UNITED STATES PATENT AND TRADEMARK OFFICE

10/625,467

Office Action Summary

DETAILED ACTION

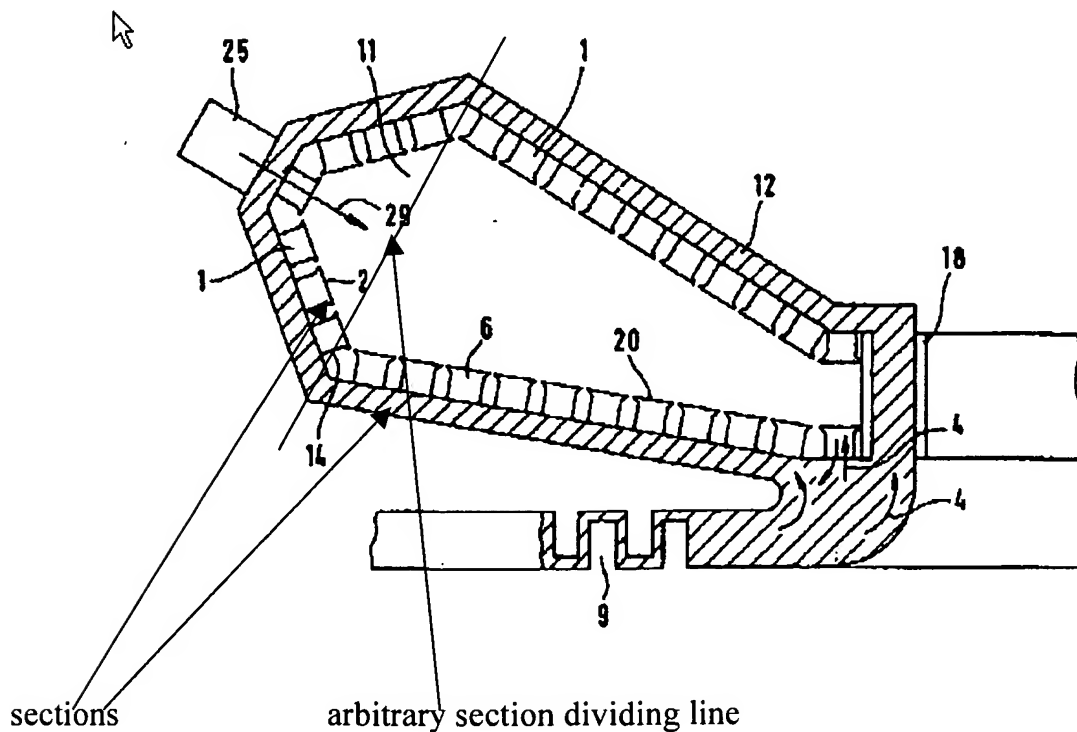
2. Claims 1-4, 6-9, 11 are rejected under 35 U.S.C. 102(e) as being anticipated by Snyder (2002/0116929). Snyder teaches an annular combustor for a gas turbine, comprising a wall, an inlet side, and an outlet side, the inlet side configured and arranged to accept burners 76 opening on the inlet side, the combustor extending in an axial direction from the inlet side to the outlet side, cooled liner segments 46, 48, 60, 62 lining sides of the wall for protection from hot gases, wherein the liner segments are subdivided in the axial direction into a plurality of parts arranged one behind the other; wherein the liner segments 46, 48 and 60, 62 are subdivided into two parts; wherein the liner segments are subdivided where the flow velocity of the hot gases is low; wherein the liner segments are subdivided in such a way that the lengths of the individual segment parts in the axial direction are approximately the same; a plurality of segment carriers 50, 44 and 64, 66 the liner segments are fastened to the segment carriers, the segment carriers

50, 44 and 64, 66 are being subdivided in the axial direction into a plurality of parts; wherein the liner segments are convection-cooled (see Fig. 3); wherein the subdivided liner segments are separately convection-cooled; the cooling medium flowing through those parts of the liner segments which are situated downstream, the cooling medium being released into the hot-gas flow of the combustor; wherein parts of the liner segments 48, 62 which are located downstream are cooled only by part of the mass flow provided overall for the cooling of the liner segments; at least burner 76 positioned at the inlet side.

segment carriers segment carrier dividing point

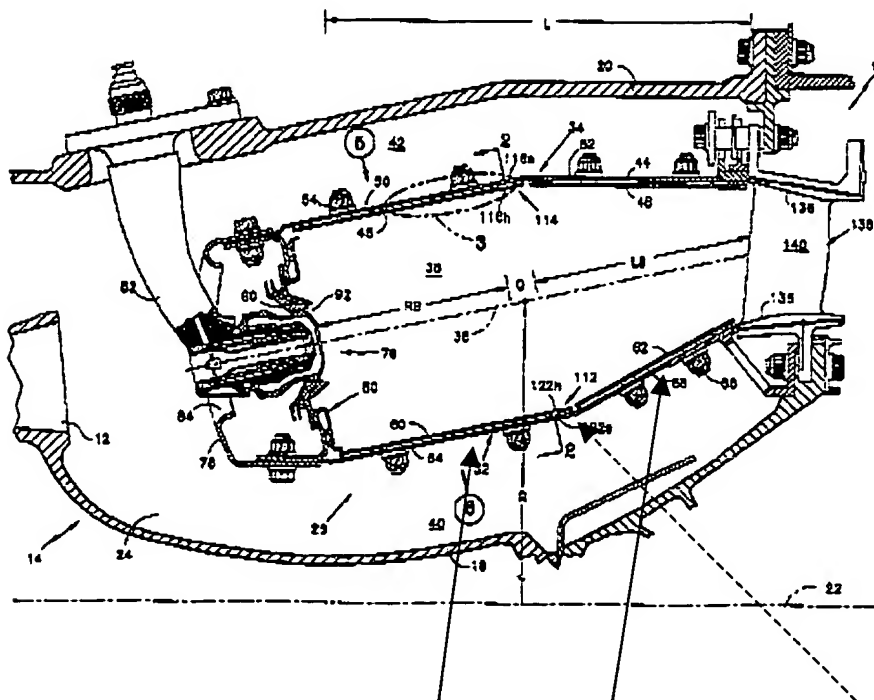
9. Applicant's arguments boil down to the meaning of "a plurality of segment carriers, the liner segments being fastened to the segment carriers, the segment carriers being subdivided in the axial direction into a plurality of parts." Applicant's arguments are not persuasive as they rely on an overly narrow construction of the claim limitations,

even arguing that the disclosed invention has separate pieces which are sealed by means of e.g. two seals. However, In response to applicant's argument that the references fail to show certain features of applicant's invention, it is noted that the features upon which applicant relies (i.e., the seals, the segment carriers being separated) are not recited in the rejected claim(s). Although the claims are interpreted in light of the specification, limitations from the specification are not read into the claims. See *In re Van Geuns*, 988 F.2d 1181, 26 USPQ2d 1057 (Fed. Cir. 1993). Furthermore, the claim limitations only require that the plurality of segment carriers be subdivided in the axial direction into a plurality of parts. Hence, each of the applied references teach the segment carriers have multiple portions. For instance in Snyder, the segment carriers can be fairly construed as below even if the segment carriers are joined (there is no requirement that the portions be separated or sealed as argued by applicant).

Furthermore for the DE '611 (Scott) reference, the sections 26a, 26b being welded together by welding seam 90, each section 26a, 26b is clearly a segment – they even have their own reference numbers.
